Limited Visual Dam Safety Inspection Summary Report

HI - 00136

Waikoloa 50 MG Reservoir 3

May 2006

Another view of the downstream slope, notice tall grass/bushes

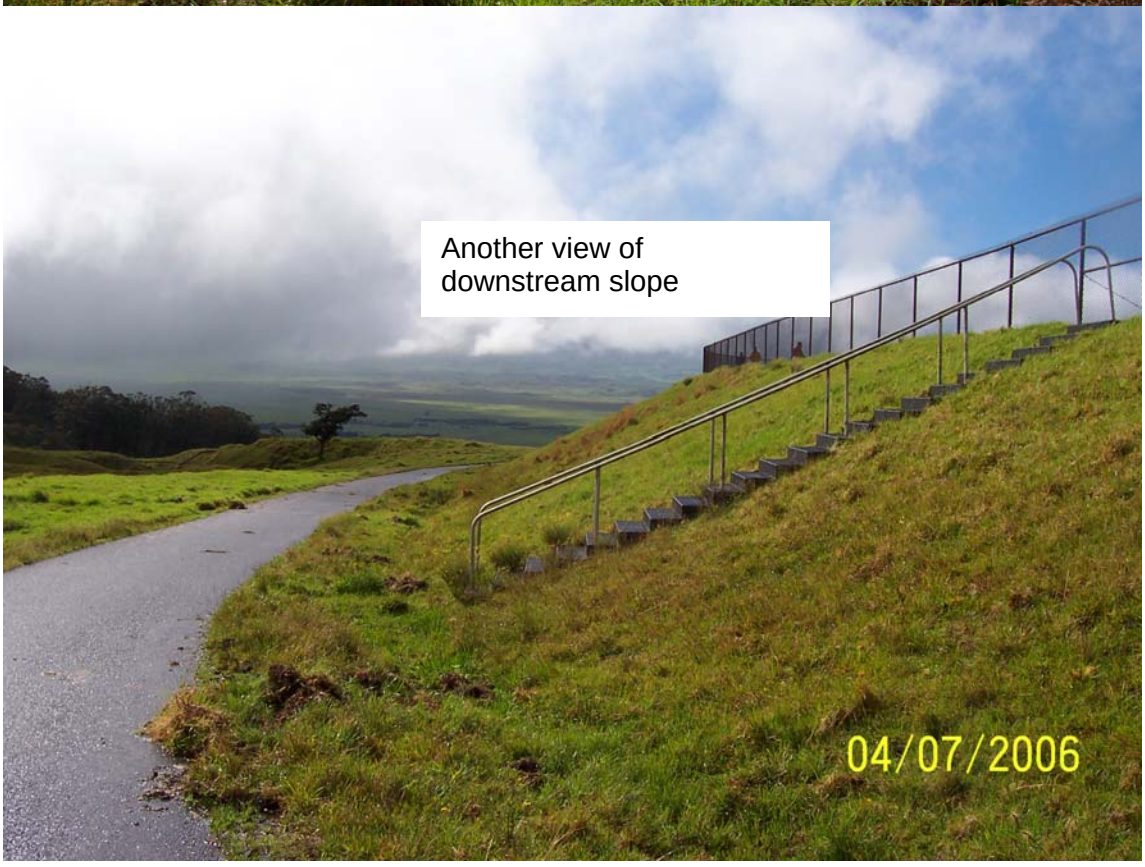
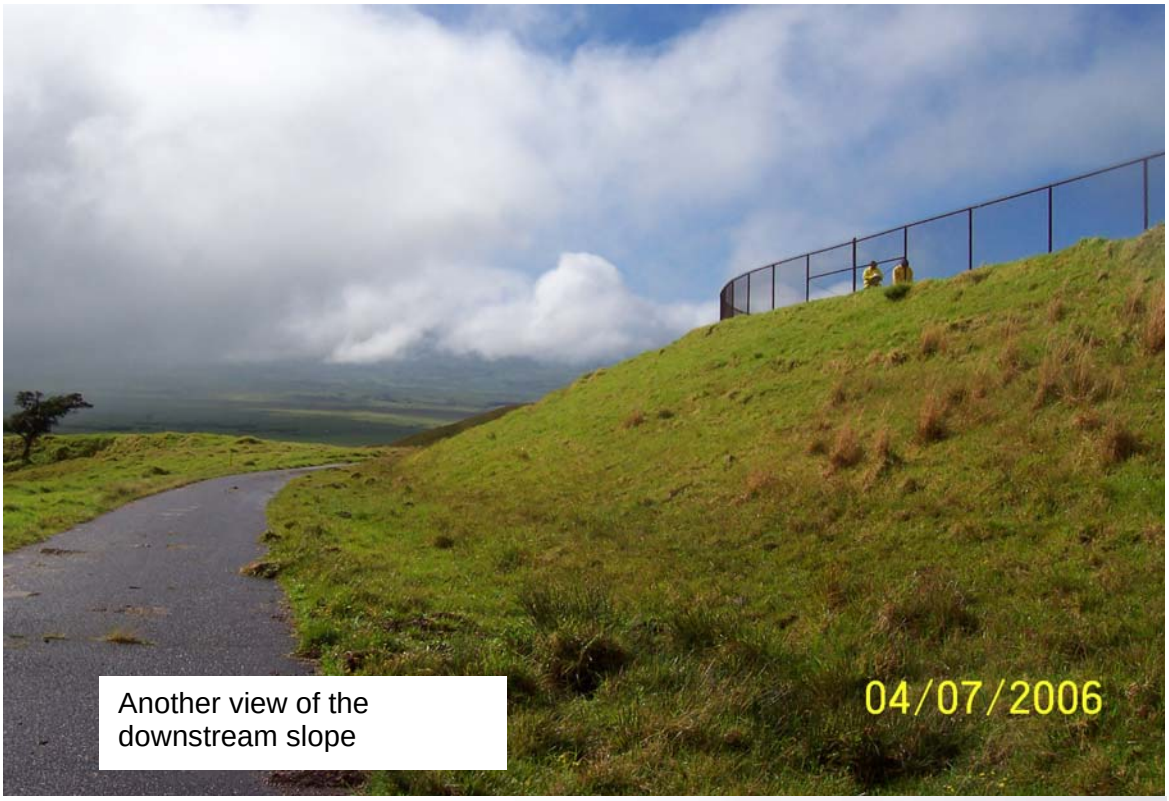
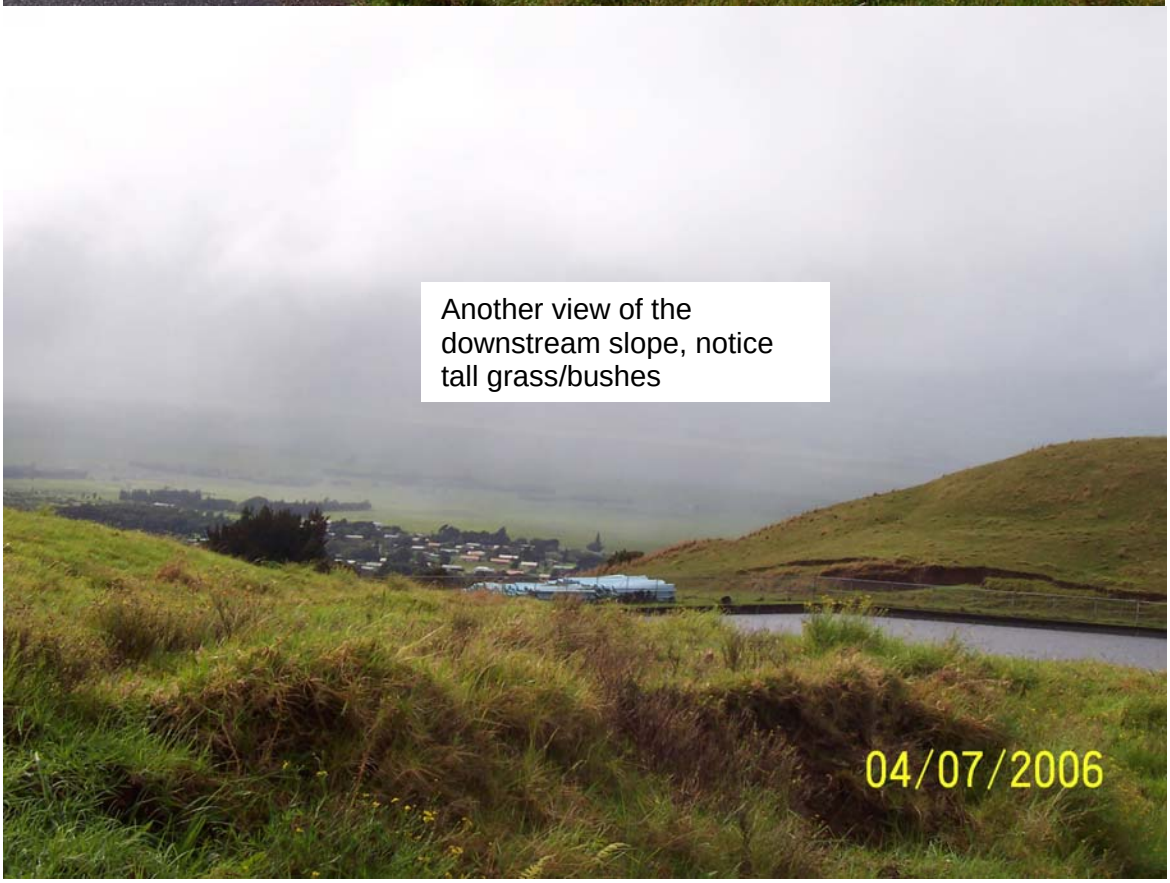
a. The downstream slope was not fully inspected.
b. The downstream slope appeared to be in fair to poor condition and requires corrective action.
c. The down stream slope was not visible due to high grass and bush vegetation. Clear high vegetation and maintain low to enable easy visual inspection.
